Intel® 80219 General Purpose PCI Processor

Specification Update

July 2004

Document Number: [274020-002](#)

Figure 2. Intel® 80219 General Purpose PCI Processor P_BMI Signal Implementation for Intel® 80219 General Purpose PCI Processor B-0/B-1 Stepping

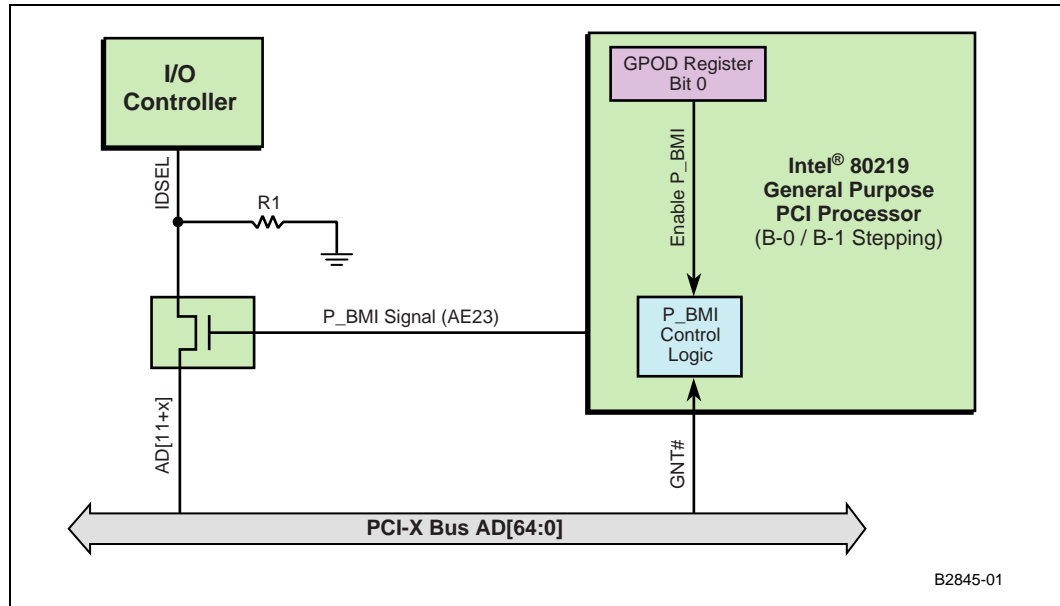
1. Signal NC2 was renamed to P_BMI (AE23). New function added to signal P_BMI.

The P_BMI (AE23) signal has been added to the Intel® 80219 general purpose PCI processor. This signal replaces, using an external GPIO pin for Initialization Device Select (IDSEL) control of an I/O device during host configuration cycles.

The 80219 has eight integrated General Purpose Input Output (GPIO) pins, referred to as GPIO[7:0]. These pins, along with the new PCI-X Bus Master Indicator (P_BMI) signal, can be used to control the IDSEL to the I/O device. External circuitry is no longer required other than a simple switch. The output function of the P_BMI signal is controlled by the GPIO Output Data Register (GPOD), Bit 0 as shown in Table 1. The P_BMI signal is always driven and defaults to driving low at power up.

The IDSEL signal is used as a chip select during configuration cycles initiated by the BIOS, operating system or 80219. The GPOD[0] can be driven low in firmware, thereby disabling the P_BMI signal and hiding the host I/O device from the system, by turning off its IDSEL. When the 80219 intends to perform configuration cycles in the PCI bus segment of the I/O device, the P_BMI signal should be asserted high by driving the GPOD[0] high. The affect of these two operations is, that the I/O device is initialized and controlled by the 80219. More care must be taken with the gate chosen to control IDSEL, since most host bridge controllers do not use PCI address stepping. With IDSEL being a synchronous signal, with respect to CLK, the switch used must be a sub nanosecond propagation delay device (e.g., Pericom PI5C3303). In Figure 2, the P_BMI signal is used to control a MUX/DeMUX switch that is used to enable/disable IDSEL to the I/O device.

Note: The host BIOS does not require any modifications to accommodate this implementation. All the responsibility for I/O device configuration and resource falls to the 80219 firmware.
